Hi Chris. I've looked closely at the two worst case Peak Excursion Plots for both the Low and Mid UNII Bands. The top line looks at the absolute maximum that occurred and the lower line looks at the very minimum that occurred. There does not appear to be any point within the occupied band width where the difference between the peak and measured power would exceed the 13dB threshold.

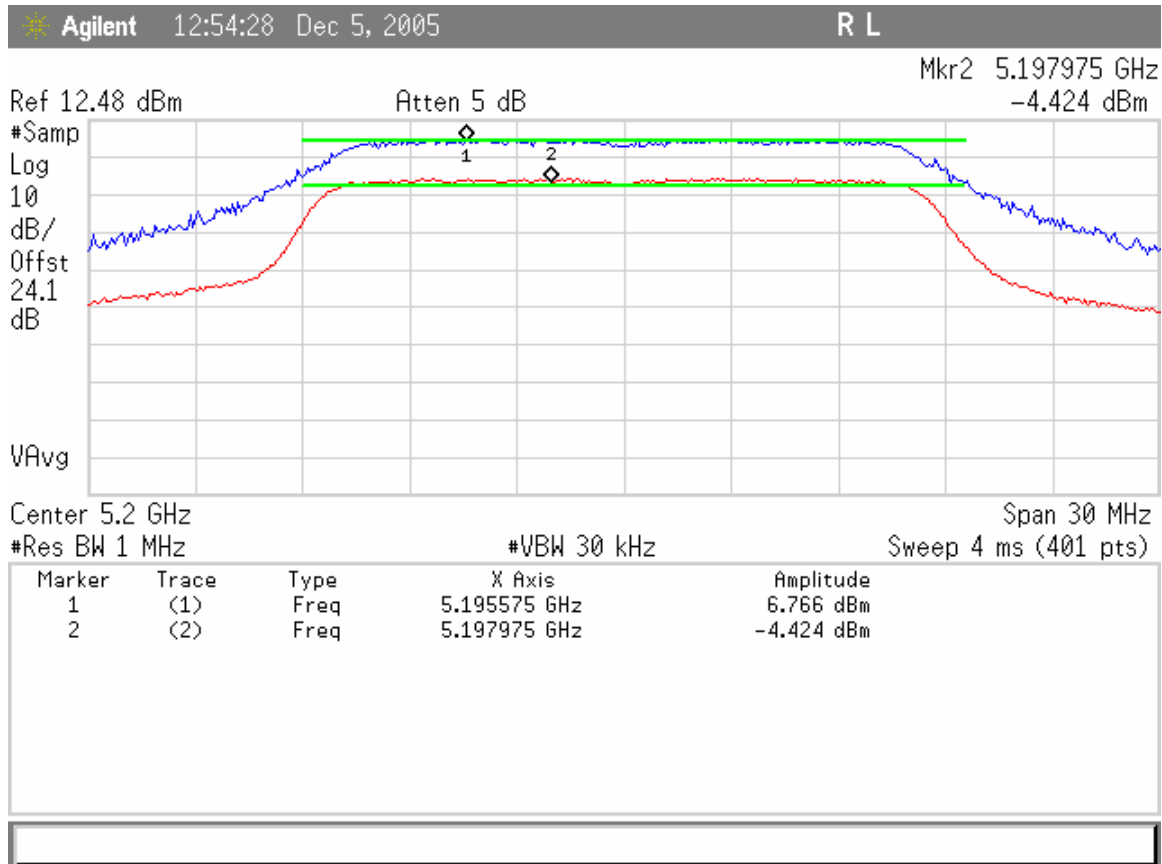
Please see graphs below to support finding.
